Top Gear
 Bronze Bushing
 P/N 13136-041

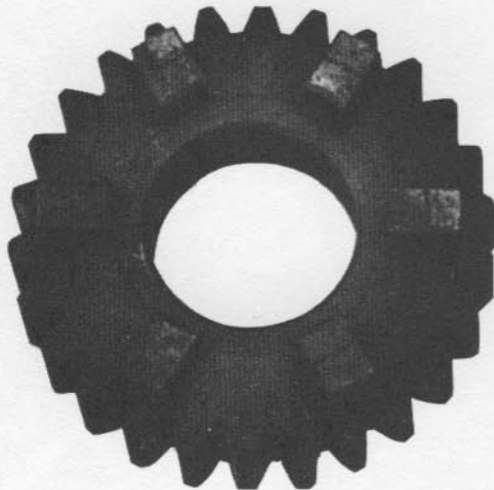
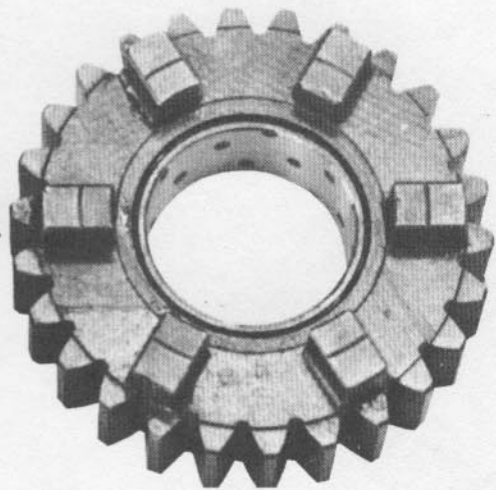
In the transmissions of H1 models there is a possibility for unusually fast wear on the inside of top gear on the drive shaft. As the gear wears, it begins to wobble on the shaft, eventually causing serious trouble in the transmission.

To eliminate this possibility, top gear on the drive shaft has been changed. The new gear is made with a pressed in bronze bushing for extended life. This change has been applied to all H1's in production from frame number KAF-57161, and to all H2's from beginning of production.
